Site Accessibility Evaluation

Patty Jewett Junction Play Area

SUBJECT: Patty Jewett Junction Play Area Self-Evaluation

Finding: 2

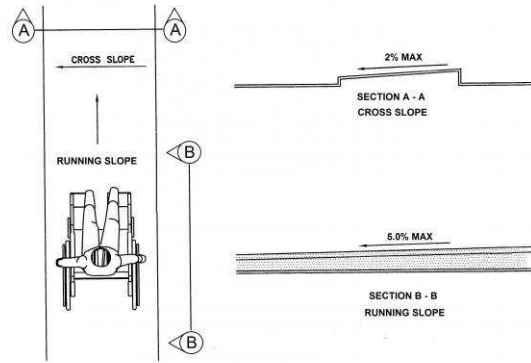
The accessible path of travel has cross slopes greater than 2%.

The sidewalk in front of the entrance to the playground has two pads with excessive cross-slope measuring 2.3% and 2.5%.

Remove and replace pads to compliance.
